TRAIN-Z_MMU_V101r3 (top)

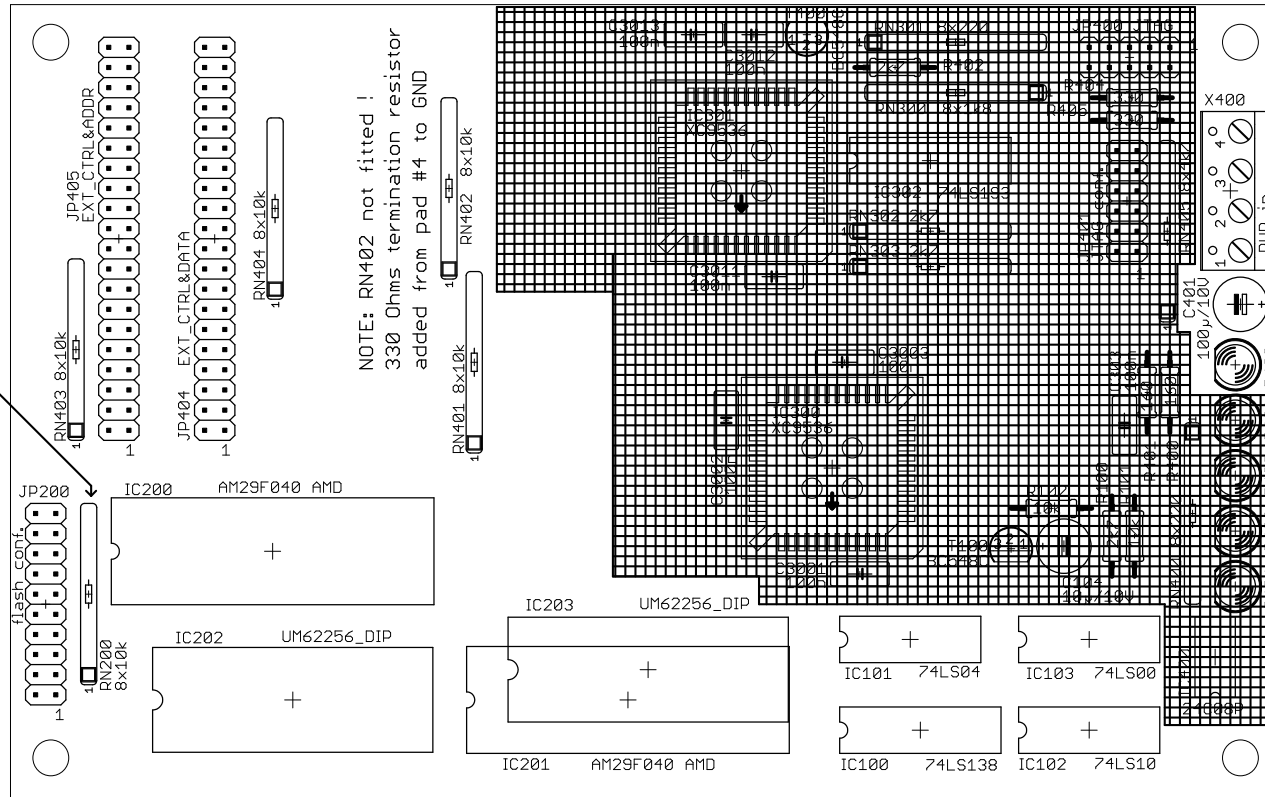
NOTE: hatched areas not fitted !

CAUTION: Watch RN200 when removing IC200 !

NOTE: RN402 not fitted !
 330 Ohms termination resistor
 added from pad #4 to GND

NOTE: pins 1 and 2 of IC200 and IC201 solder bridge.
